## Executive Director's Recommendation

<b>PROJECT</b> <b>DIAC Parking Garage Replacement</b> Joint Base Anacostia – Bolling Defense Intelligence Agency Headquarters Washington, DC	<b>NCPC FILE NUMBER</b> 7549
	<b>NCPC MAP FILE NUMBER</b> 84.22(61.10)44180
<b>SUBMITTED BY</b> Department of the Navy	<b>APPLICANT'S REQUEST</b> Preliminary and final approval of site and building plans
<b>REVIEW AUTHORITY</b> Approval of Comments on Plans Located in the Bolling-Anacostia Complex Pub. L. No. 93-166 Section 610(a)	<b>PROPOSED ACTION</b> Approve with comments
	<b>ACTION ITEM TYPE</b> Consent Calendar

The United States Department of the Navy has submitted preliminary and final site and building plans for a parking garage replacement at the Defense Intelligence Agency Headquarters (DIAC) located at the Joint Base Anacostia-Bolling installation.

Figure 6: Proposed Height

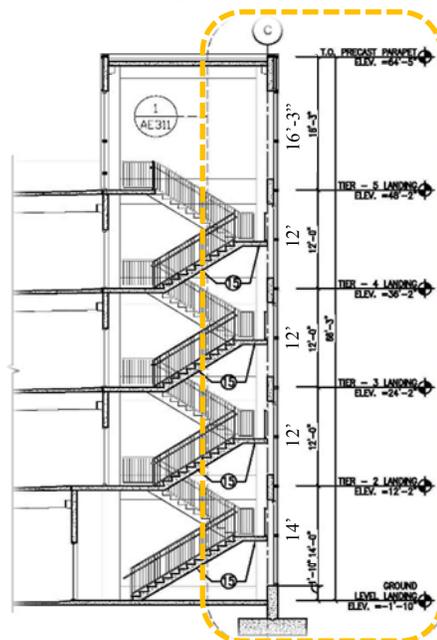
The five-level parking garage would have four elevated parking levels in addition to an at-grade parking level. The new parking garage would be 232,911 square feet of gross floor area with a height of 66.3 feet above grade. The height from grade to the top level of the garage would be 50 feet, with the elevator core and stairways rising an additional 16.3 feet above the top level (Figure 6). The parking garage would be located so that the building heights and setbacks are compatible with the adjacent buildings and no higher than the existing DIAC building.

Figure 7: Pre-Development Drainage Area Map

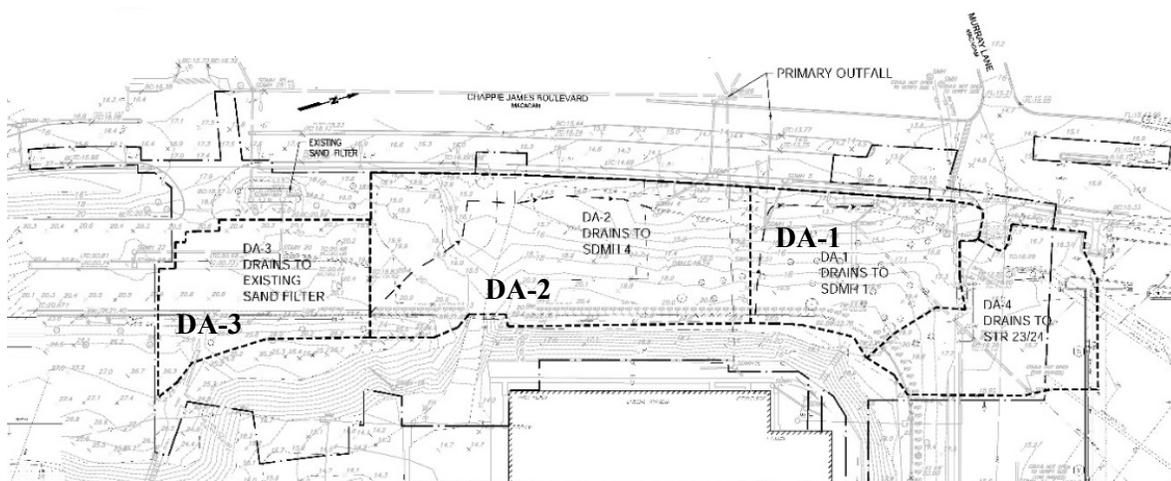
The existing site generally includes three drainage areas (DA) that combines into a single outfall before discharging into the Anacostia/Potomac Rivers (Figure 7).

Figure 8: Post-Development Drainage Area Map

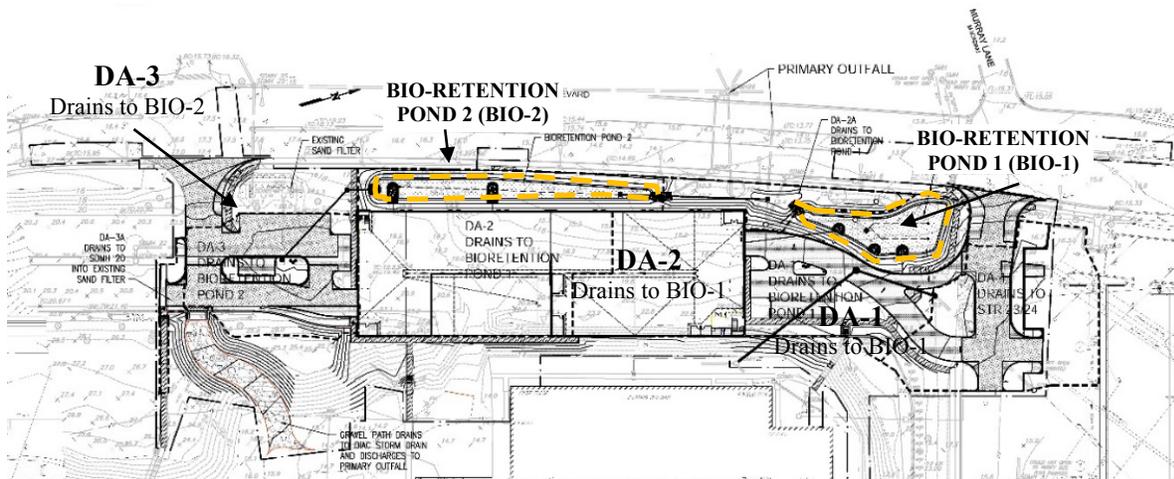
The proposed stormwater management is designed in accordance with District Department of the Environment (DDOE) methodology and procedures. The proposed project incorporates low impact development (LID), adding two bio-retention areas to manage stormwater runoff. The bio-retention proposed north of the parking garage would accommodate a volume of approximately 6,257 cf of runoff. The bio-retention proposed along the western boundary of the project site along Chappie James Boulevard would accommodate a volume of approximately 10,203 cf of runoff (Figure 8).

The proposed project includes bio-retention areas, which would detain runoff for the 95<sup>th</sup> percentile rain event, designed to accommodate the volume requirement of 4,042 cf. This bio-retention as sized would meet both DDOE and EISA 438 stormwater requirements.
